GLOBAL SAFETY FIELD INVESTIGATIONS  
DCS5002  
URGENT - DISTRIBUTE IMMEDIATELY

Subject: N182188910-01 - Special Coverage  
PPS Setting DTC For Airbag Light On  
Updated Customer Letter

Models: 2017 Buick Verano

**Revision Description:** The customer letter has been updated. Please discard all previous copies of bulletin N182188910.

4505465

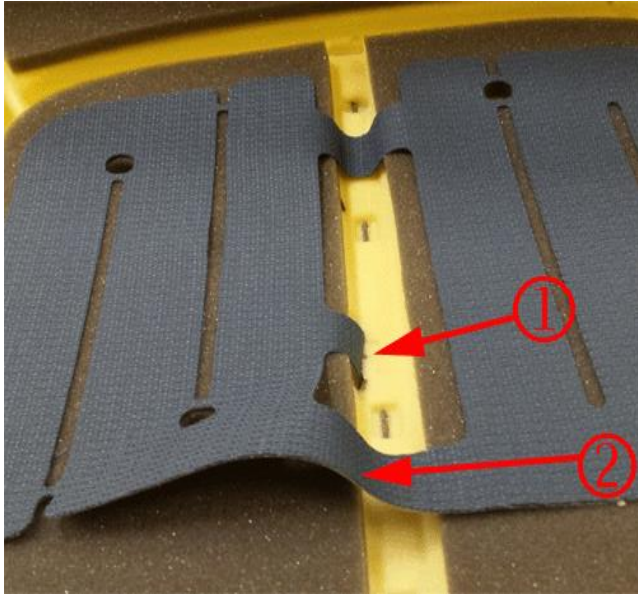
**Note:** Sensor tail observed trapped between seat trim tiedown feature and cushion pad.

2. Upon inspection of the sensor after trim removal, a sharp crease in the passenger presence sensor in the area where the sensor tail exits through to the bottom of the seat cushion assembly may be observed.

**Note:** When reassembling the seat, take great care to not create a crease in the tail of the passenger presence sensor.

4505468

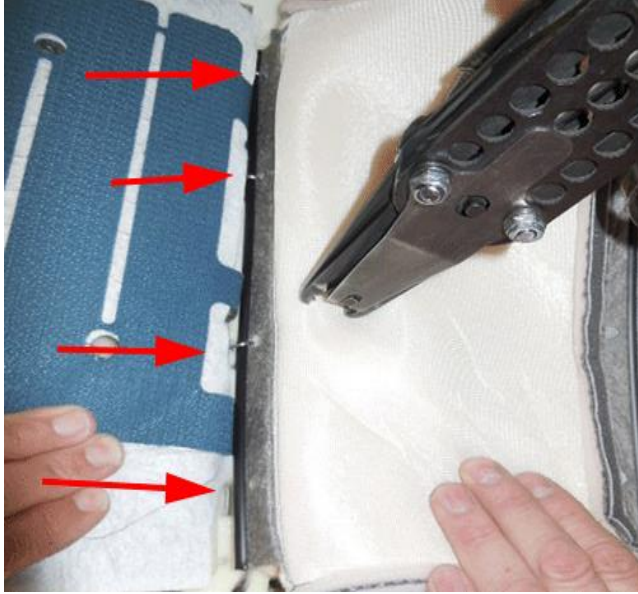
6. Ensure the sensor pigtail is fully pulled through the seat pad. The white felt patch on the harness should start to be seen below the surface of the pad.
